## AIO-16 Noise detected on Same Card Mixes / Cross-Connects

This modification has been released via Engineering Change F03X014208 and will be present on all units shipping from October 2013 forward.

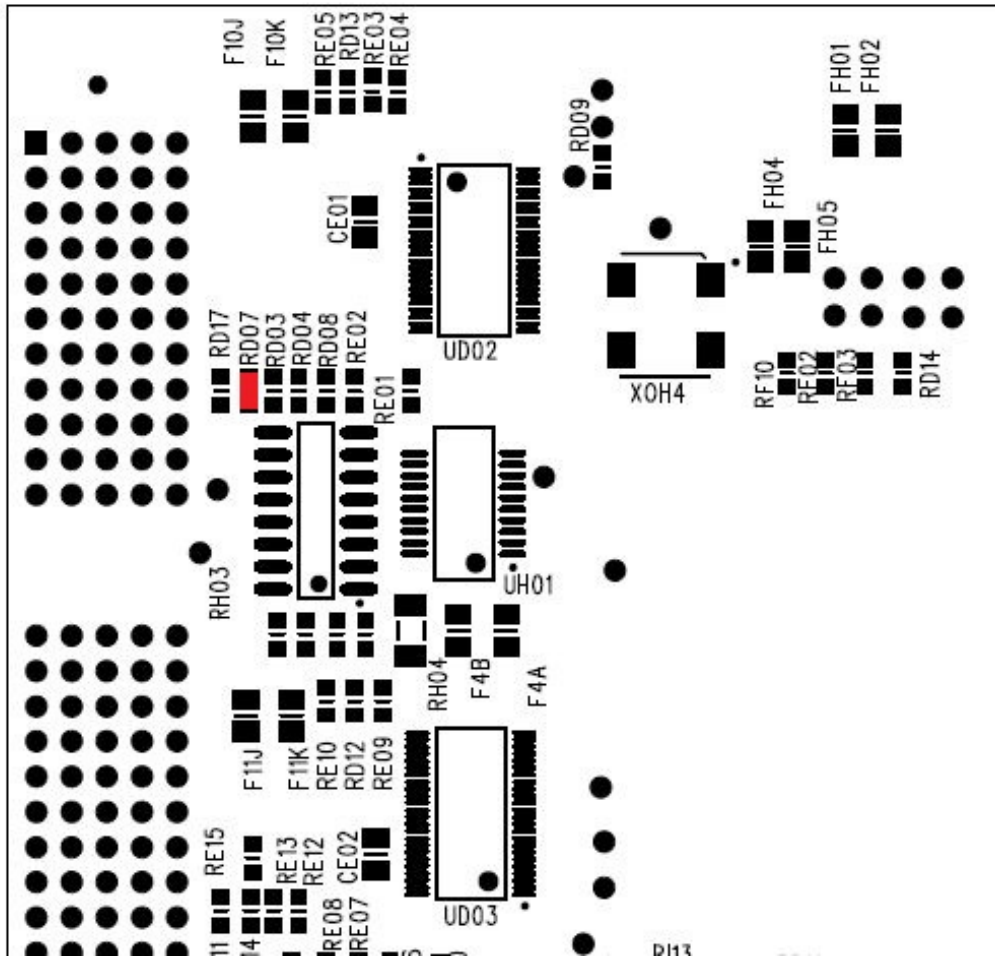
The root cause of this issue in timeslots cross-connected on the same card is that the data delay path is very low. HOLD time requirements are not satisfied for the TDM data being clocked back into the AIO-16 card. Data is improperly sampled and corrupt samples are passed through to the codecs and D/A converters. These are perceived as audible pops / clicks on the AIO-16 analog ports.

The data HOLD time requirement for the AIO-16 is approximately 1.1 nsec. In units where the audible noise is detected, the HOLD time is measured to be less 1 nsec. There is a programmable clock generation IC on the AIO-16 (and the other ADAM cards) which is responsible for the generation of the various sampling clocks in the design. These clock generation ICs allow for the phase delay of the outputs to be adjusted by resistor settings.

Specifically, installation of a zero Ohm 0603 size resistor (F.01U.162.707 or equivalent) in location RD07 will correct the problem. This produces a 2.8 nsec shift in the receive TDM sample clock and creates sufficient hold time to eliminate the improper sampling.

Install 0 Ohm resistor F.01U.162.767 in location RD07 (see diagram on following page). Note that this location should currently be unpopulated on an unmodified AIO-16. If the location already has a zero Ohm resistor, this indicates the card has already been corrected and re-tested.
